JULY 26, 2023
ADDENDUM NO. 1

ADDENDUM #1

**VAN NESS AVENUE
FROM REDONDO BEACH BOULEVARD TO MARINE AVENUE**

PROJECT NO. JN 992

SHT 8 OF 11

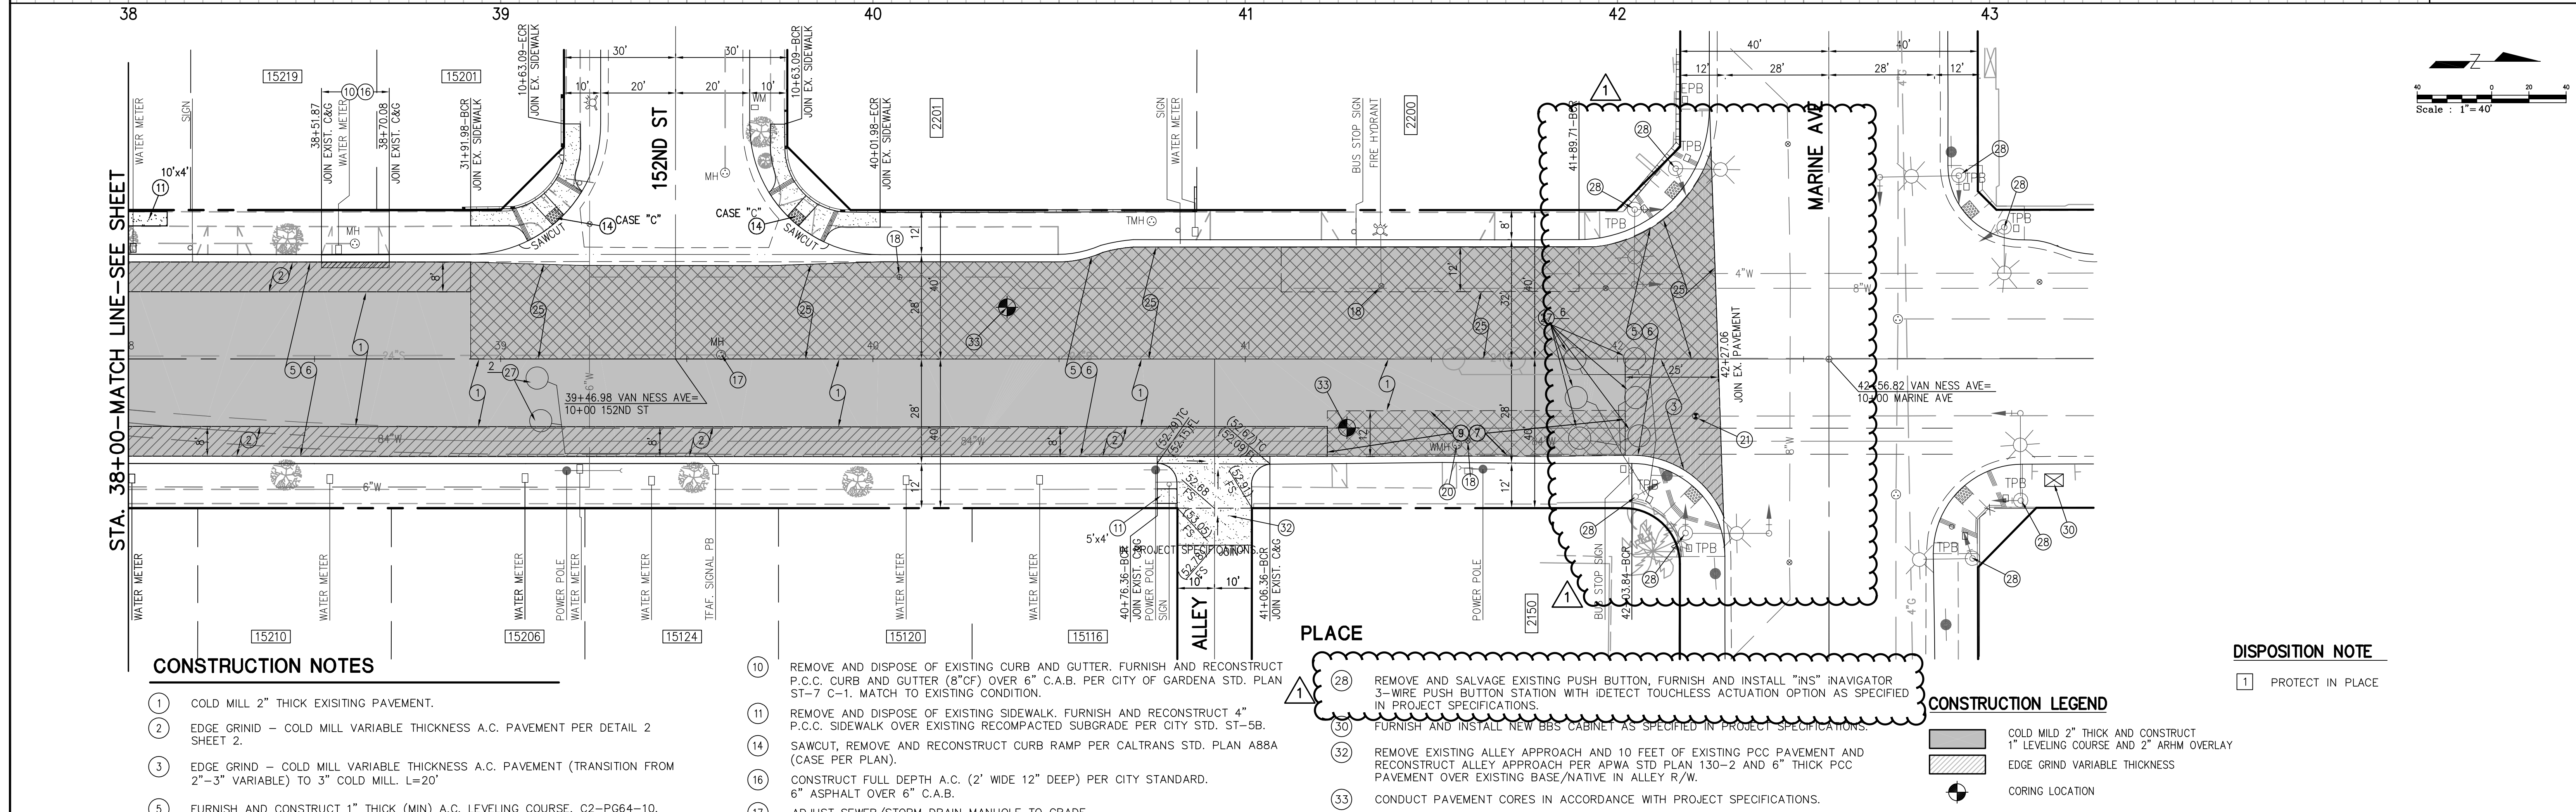
Revised Plan Sheets 1,4,5,6 and 8 are enclosed which depict the revisions to construction notes and installation of pedestrian push buttons at the Manhattan Beach, 156th Street, and Marine Avenue intersections.

- (28) REMOVE AND SALVAGE EXISTING PUSH BUTTON, FURNISH AND INSTALL "INS" NAVIGATOR 3-WIRE PUSH BUTTON STATION WITH IDETECT TOUCHLESS ACTUATION OPTION AS SPECIFIED IN PROJECT SPECIFICATIONS.
- (30) FURNISH AND INSTALL NEW BBS CABINET AS SPECIFIED IN PROJECT SPECIFICATIONS.
- (32) REMOVE EXISTING ALLEY APPROACH AND 10 FEET OF EXISTING PCC PAVEMENT AND RECONSTRUCT ALLEY APPROACH PER APWA STD PLAN 130-2 AND 6" THICK PCC PAVEMENT OVER EXISTING BASE/NATIVE IN ALLEY R/W.
- (33) CONDUCT PAVEMENT CORES IN ACCORDANCE WITH PROJECT SPECIFICATIONS.
